White Heather SHD

Statement of Response
March 2022

Project:	White Heather SHD	Proj. No.:	20016
Location:	Location	Proj. Lead:	MH
Client:	U+I (White Heather) Limited	Created by:	OOK
Doc. Title:	Statement of Response	Doc. Purpose:	PP
Doc. No.:	20016-OMP-XX-XX-RP-A-0002	Revision:	- (16-03-2022)

5.2 Context sections 01 and 02

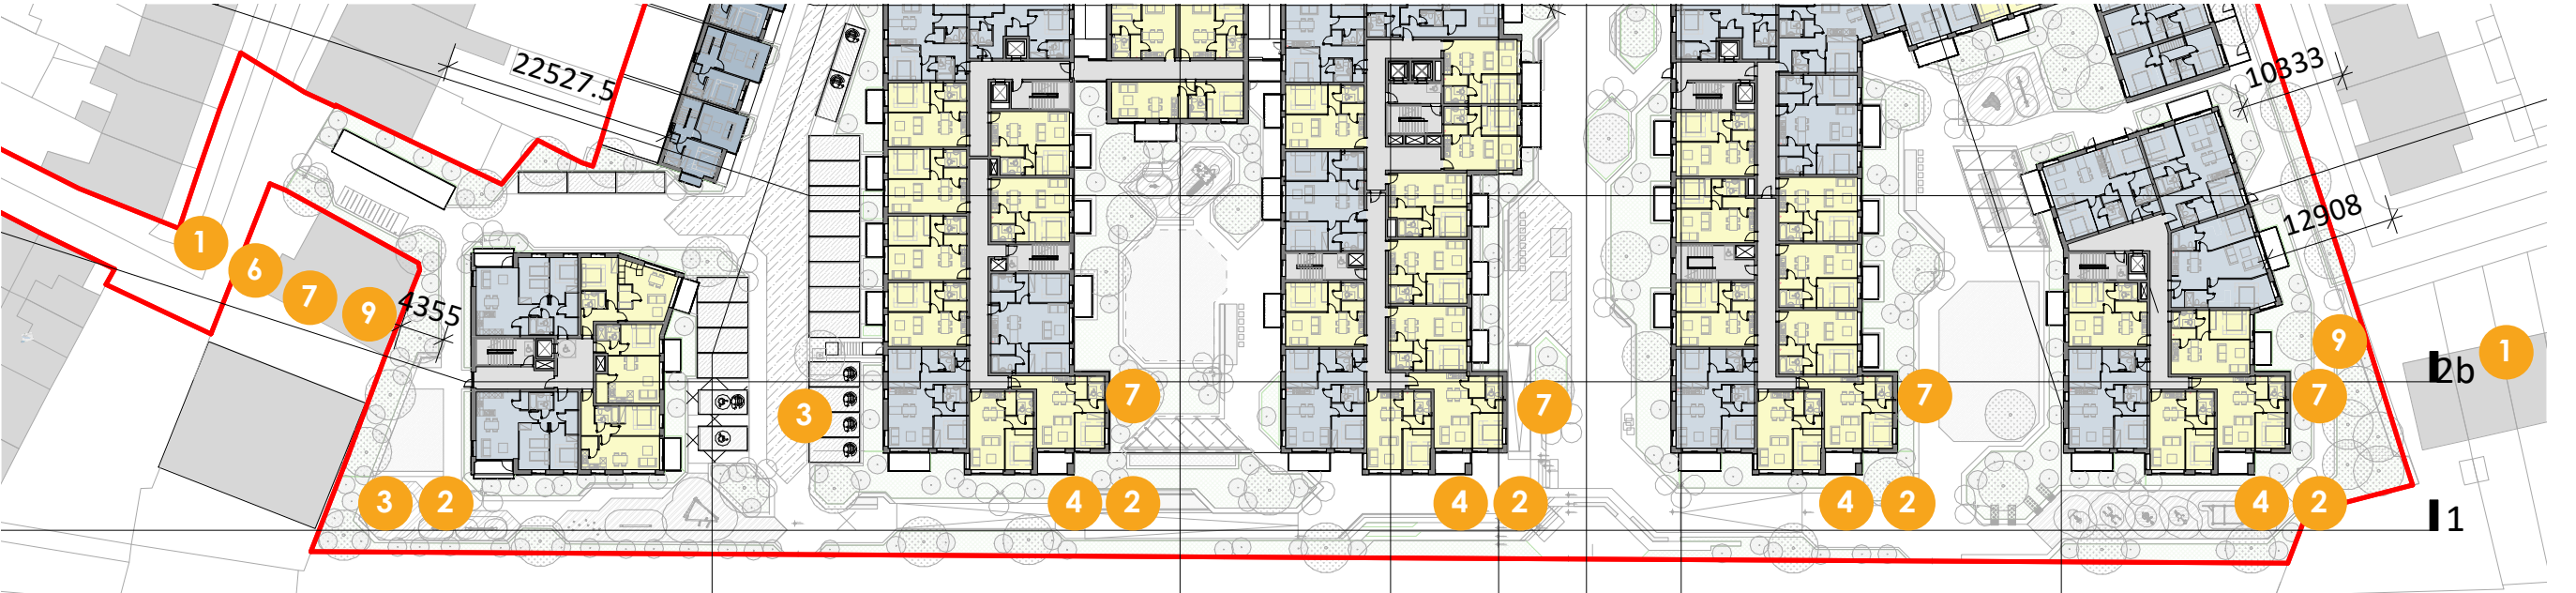
- Further details regarding the potential for any overlooking from balconies to Block B01 facing the dwellings at 1-3 and 13 St James's Terrace should be provided in order to assess potential overlooking concerns.
- The site layout plans should be updated to include the dwellings at 1-3 St James's Terrace (approved under DCC Ref: 2833/17) in order to allow for potential conflicts to be considered.
- The separation distance between the proposed residential terrace and the common boundary with the dwellings along St James's Terrace should be confirmed.
- The scope of the overshadowing analysis should be extended to include the eastern part of the site and Priestfield Cottages.

Mitigations to Reduce Potential Impacts on Privacy

- 1 Sufficient separation distances provided between the proposed development and neighbouring properties.
- 2 Inset balconies provide increased privacy for balcony users while minimising potential overlooking.
- 3 Balconies positioned to avoid direct views toward adjacent properties.
- 4 Facades recessed to provide dual aspect and screen private balconies.
- 6 Direction of Window Outlook orientated to avoid any direct views toward adjacent properties.
- 7 Blank areas of facade to avoid overlooking.
- 9 Planted buffer to site boundary wall screens views between the development site and adjacent properties.
